**UNITED STATES ENVIRONMENTAL PROTECTION
AGENCY
REGION 10**

October 26, 2017

Re: Draft Final Fourth Five-Year Review for Puget Sound Naval Shipyard (PSNS) Complex
Superfund Site, Bremerton Naval Complex, Bremerton, WA

Attachment 2

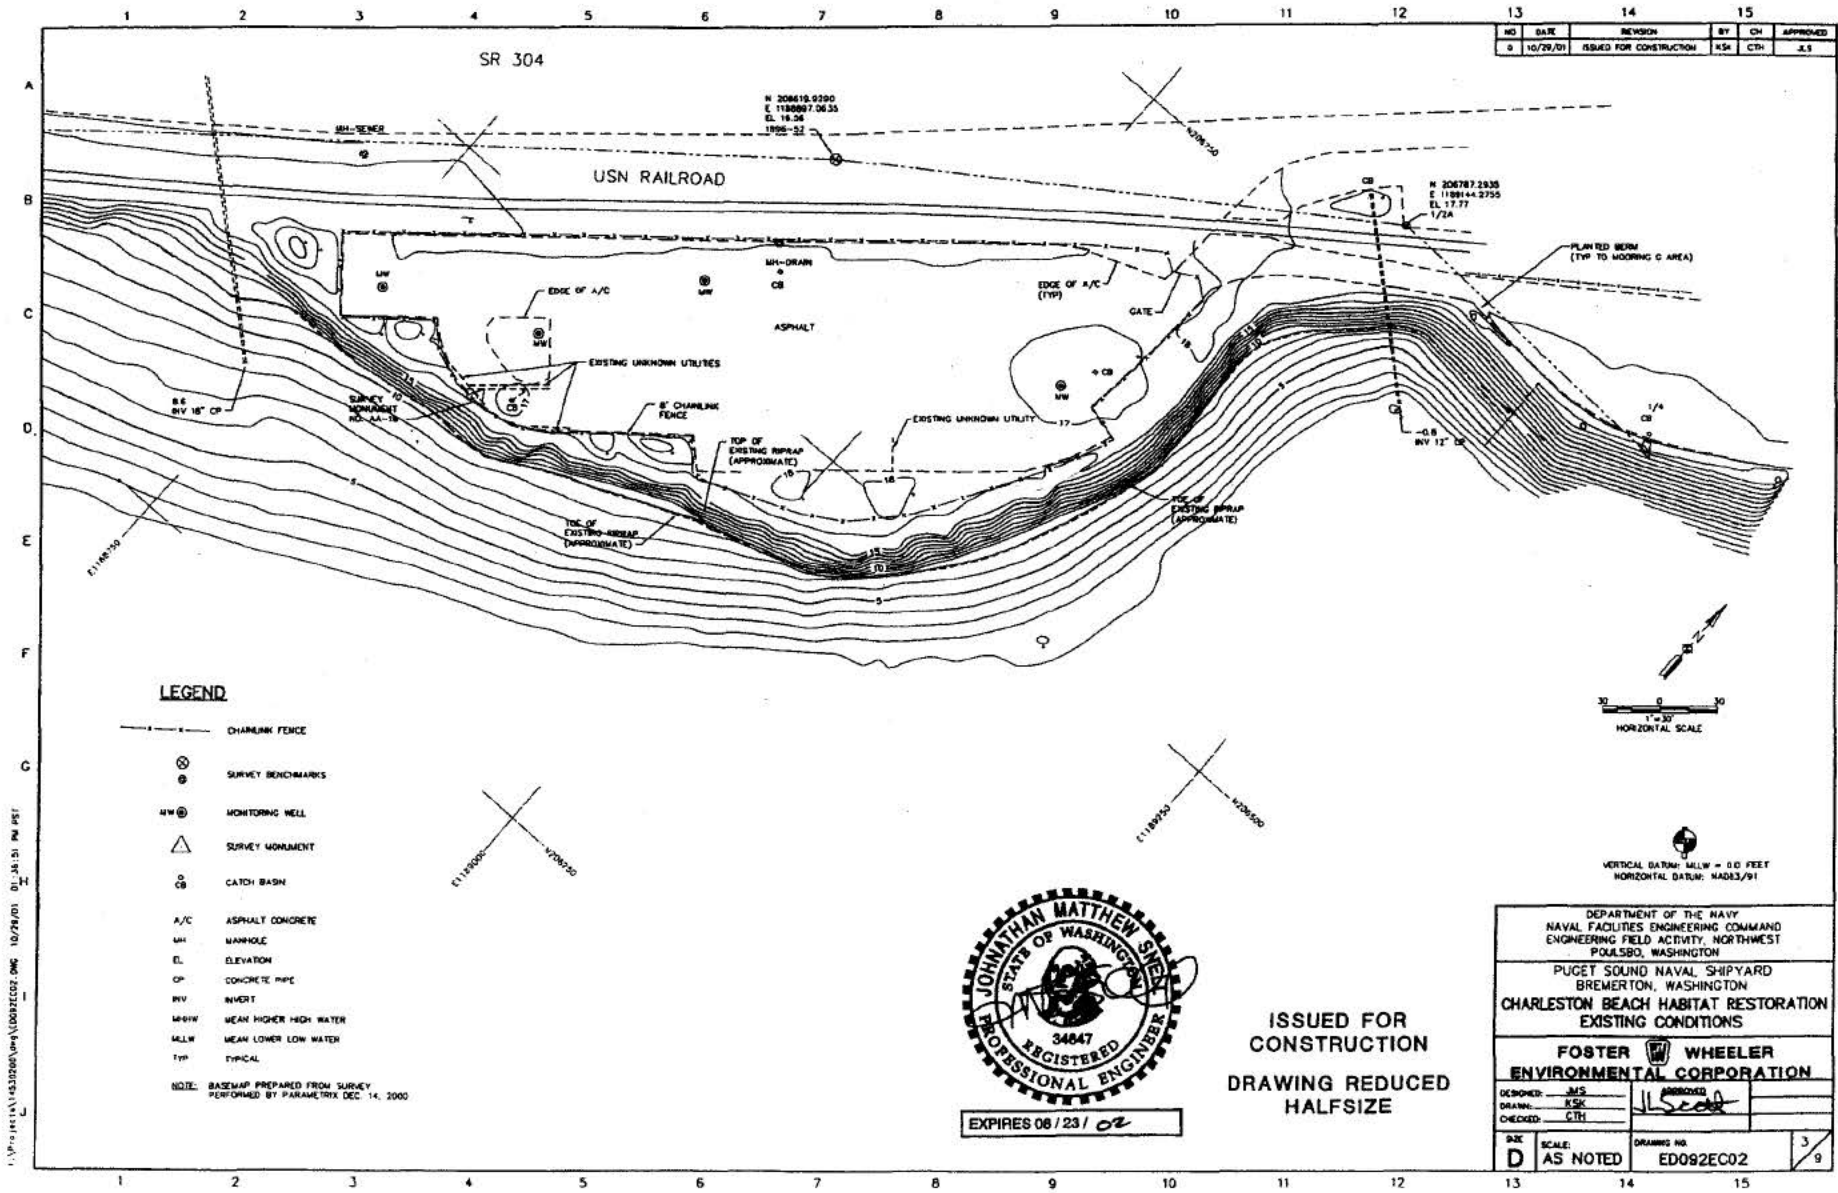
- 6) As indicated by observing the beach mix erosion gages, the beach mix has been eroding from the south west side of the beach. It appears that much of the beach material has moved to the north east side of the beach thus enhancing that area of the beach. This is evidenced by the fact that we can no longer see the top of the erosion gage that was placed on this part of the beach. Another indication that the beach mix has been moving in this direction is that the storm sewer outfall to the north west of the beach has become clogged with beach sediment. Attachments 2 and 3 show the outfall as a dotted line located at about
